URBAN DESIGN COMMISSION APPLICATION

| | (608 | 3) 266-4635 | | | | | | | | | | | |
|------------------------|------------------------------|---|---|---|--|--|--|--|--|--|--|--|--|
| | | ress (list all addro | | roject site): <u>3535-3353 Unive</u> | ersity Ave | and 737 & 733 N Meadow Lane | | | | | | | |

3575 University Ave, Madison, WI

LAND USE AND URBAN DESIGN COMMISSION SUBMITTAL

LIGHTING

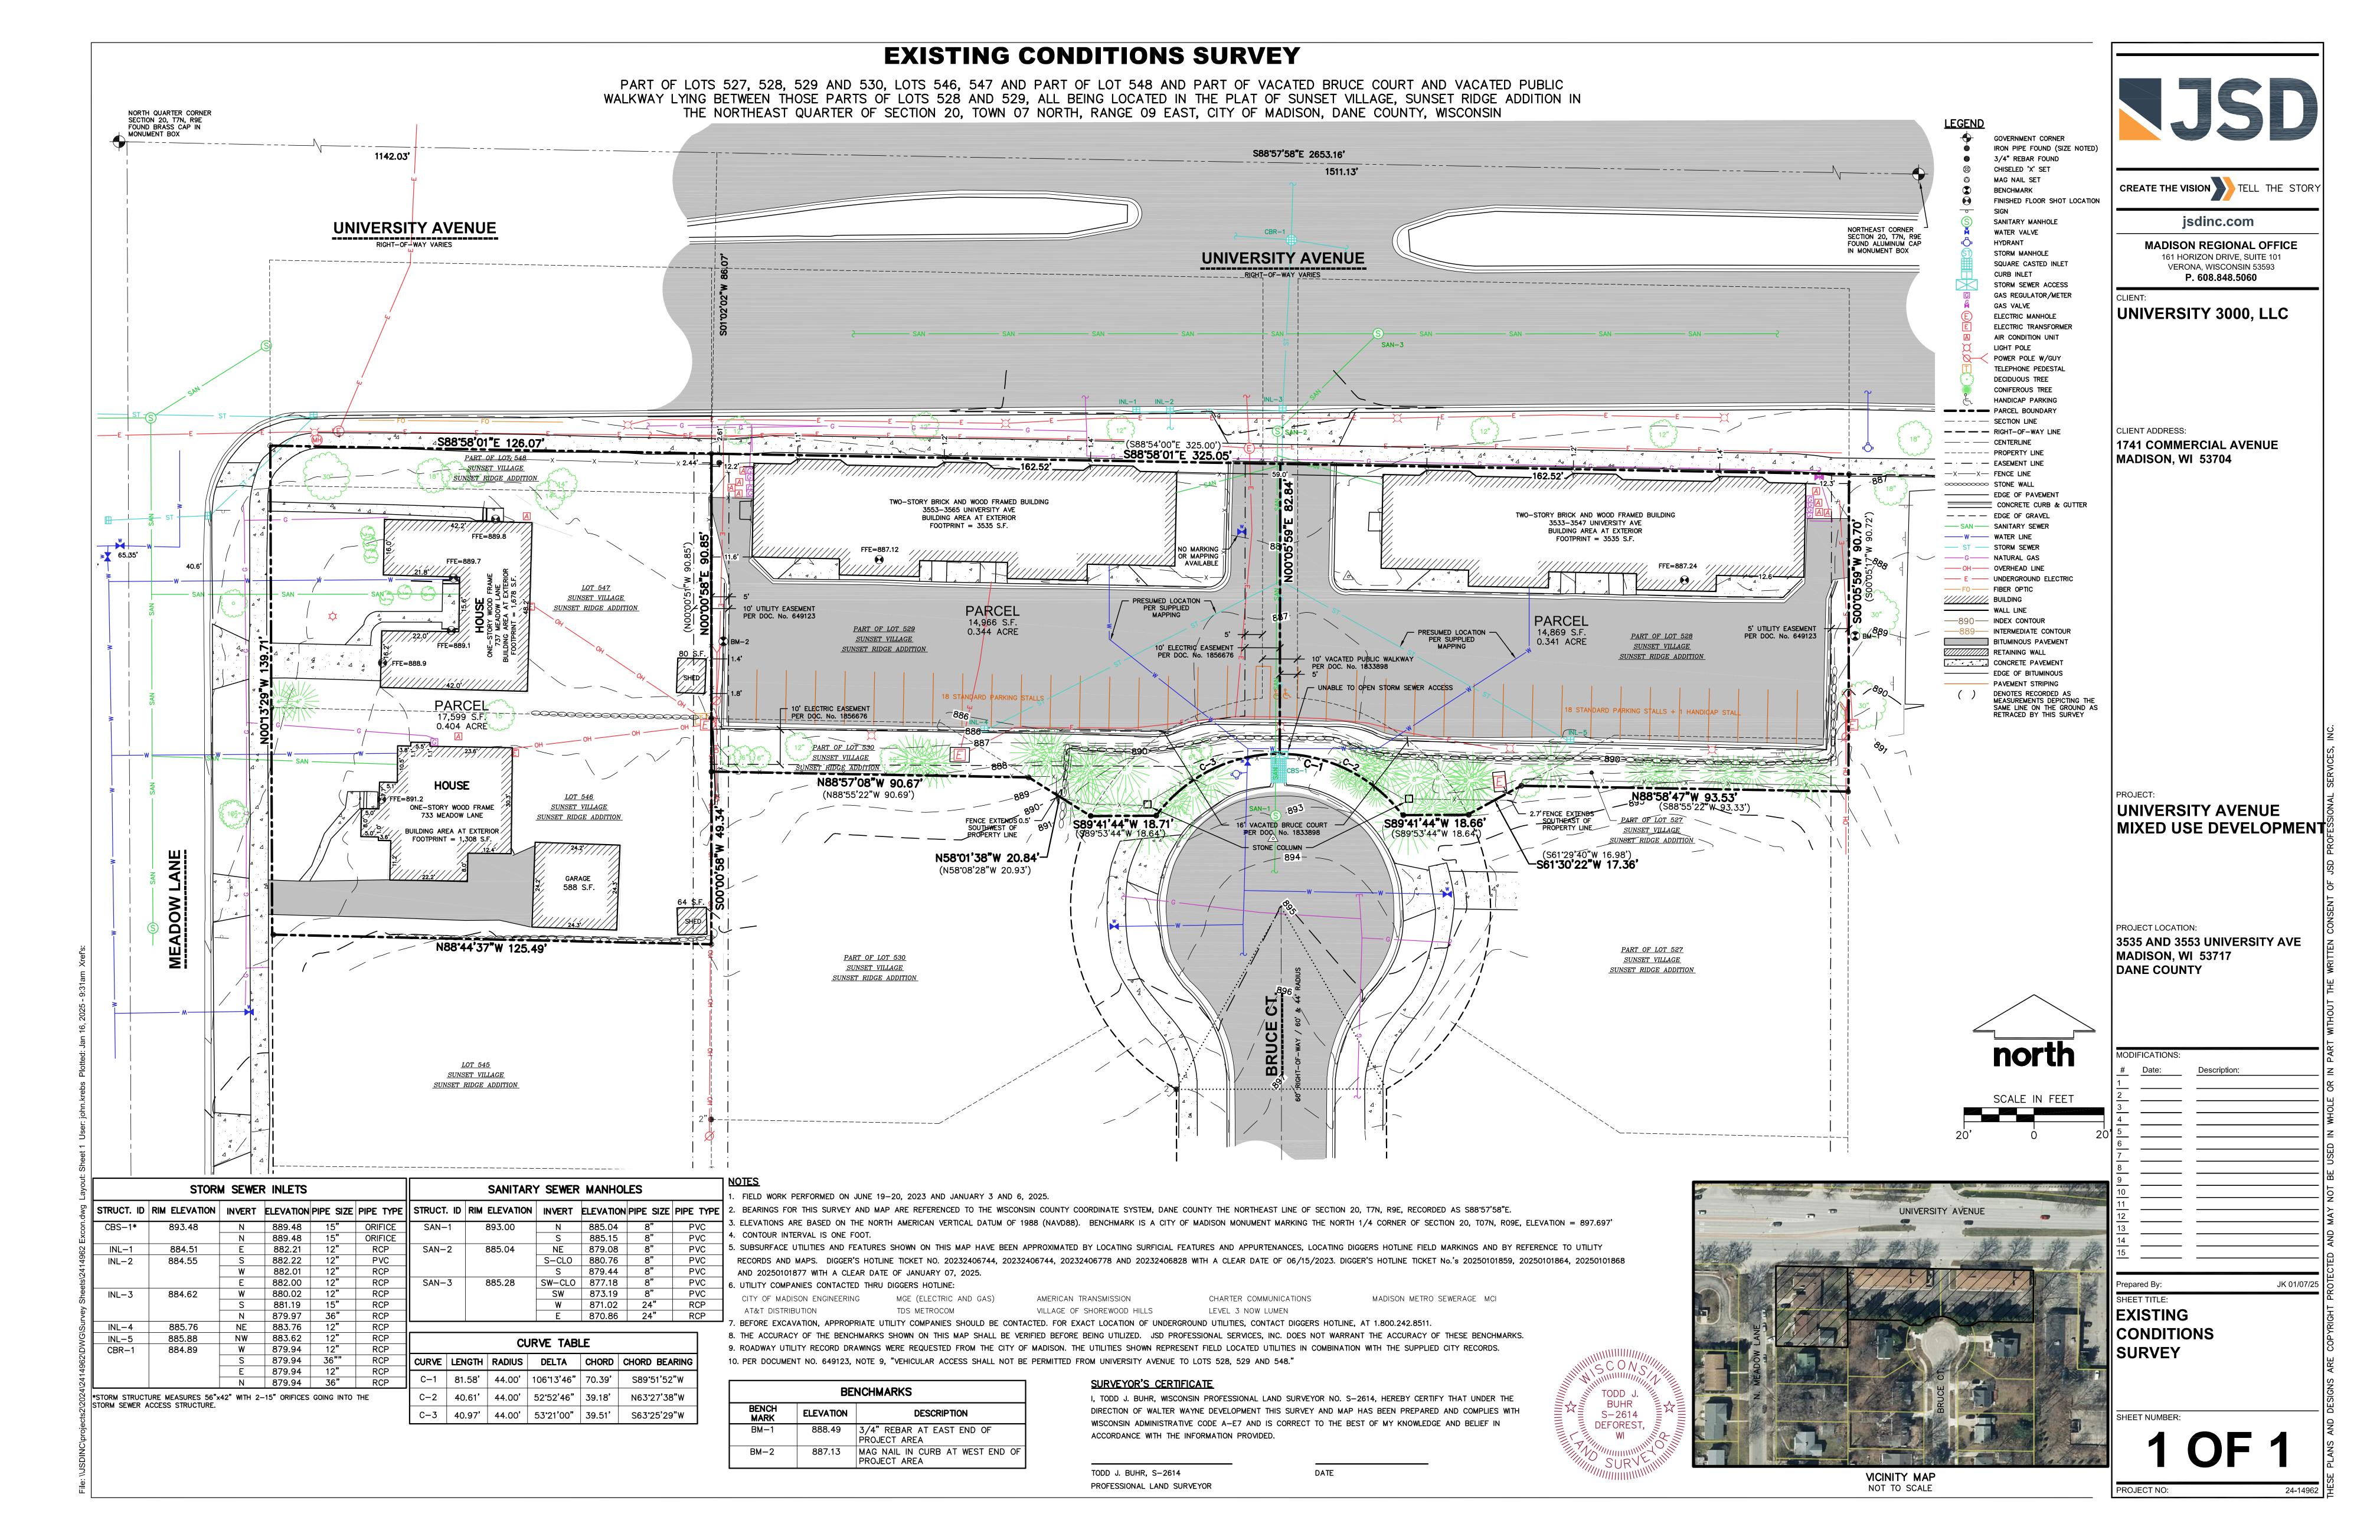
- The applicant shall address the lighting comments noted in the staff report, including revising the lighting plan and providing fixture cutsheets as it relates to rooftop lighting, architectural lighting, individual balcony lighting.

- o Rooftop lighting calculations and cut sheets are included in the revised submittal.
 - No architectural lighting or lighting high on the building is included currently.

- o The individual balcony lighting cut sheet is included in the revised submittal
 - Balcony lights will be mounted on the recessed wall of the balconies
